Our Case Number: ACP-323849-25

Formal Observation

Re: Proposed Development — Cleeves Riverside Quarter / Cleeves Riverside Campus Phase 2

Applicant: Limerick Twenty Thirty DAC

Figure 14: Interior photos of Fernbank house architecture

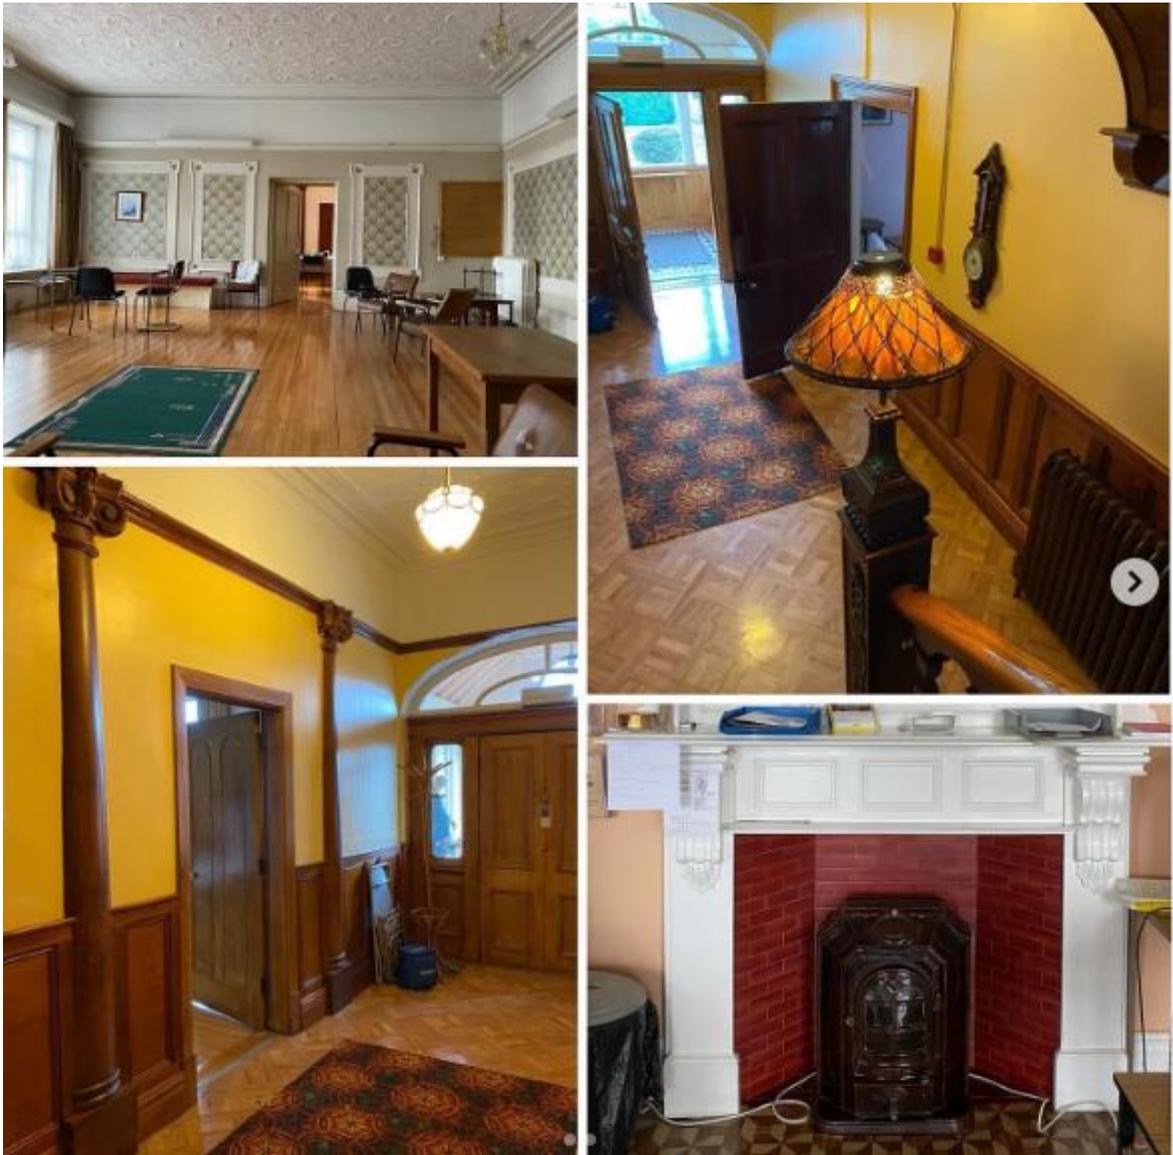
- Fernbank House, a part of the Salesians Secondary school site, not mentioned in the plans of the local authority, is an important local heritage asset. The scale, design, and materials of the proposed development are fundamentally out of character with the historical setting of the building and will result in a significant and irreversible loss of its special architectural and historic interest. The loss of a key historical view from the building and its grounds is a serious concern.

- **This vernacular architecture has for the past 155 years includes the villa of Fernbank House, the home of the Cleeves Family and an important early building on the north side of the river Shannon in Limerick City.** This proposal fails to respect the existing historical context and violates local planning policies that aim to preserve and enhance conservation areas. The fact that the owner, the local authority, has not listed this building despite its noted historic value is a problem in itself. It should be protected as a matter of urgency.

- **In the application no mention of this building is made.** It is to be demolished as per the plans. However this was one of the first buildings on the north side of the river bank at Limerick from 1800- onwards.

- Local Authority to list this building as a protected structure in alignment with local and national guidelines and as has been called for by locals and local historians alike for years, since it's purchase.
- Provide a Conservation Report and structural appraisal
- Provide a Structural appraisal and reuse proposal
- Provide adaptive reuse proposal
- Design to respond to and meaningfully integrate Fernbank house into the proposed masterplan
